Historic District Commission

Staff Report – April 15th, 2020

Project Evaluation Form: <u>232 COURT STREET</u>
Permit Requested: <u>CERTIFICATE OF APPROVAL</u>
Meeting Type: <u>PUBLIC HEARING #4 (LU-20-45)</u>

Project Address: **137 NEW CASTLE AVE.**
Permit Requested: **CERTIFICATE OF APPROVAL**
Meeting Type: **WORK SESSION #5 (LUHD-126)**

Aerial and Street View Image

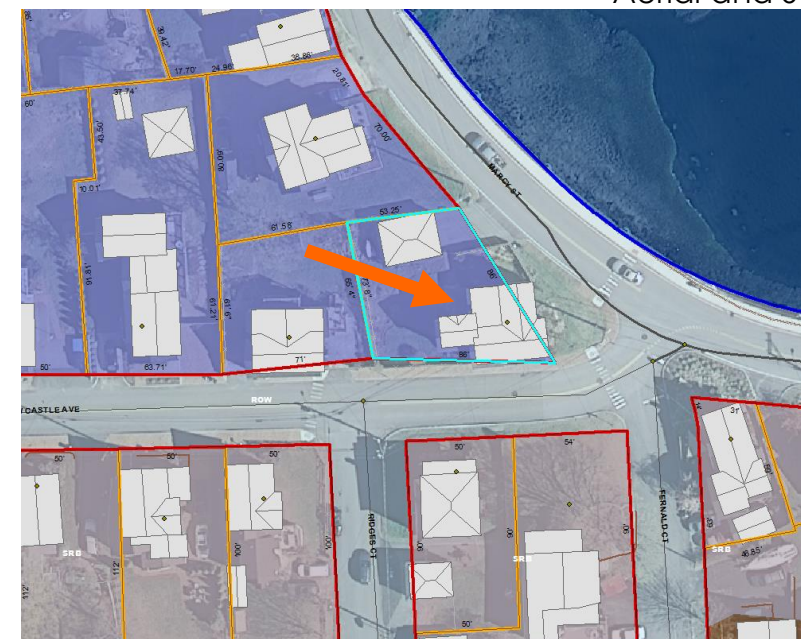
### J. Staff Comments and/ or Suggestions for Consideration:
The applicant is proposing to:
- Install a roof covering over the existing rear patio.
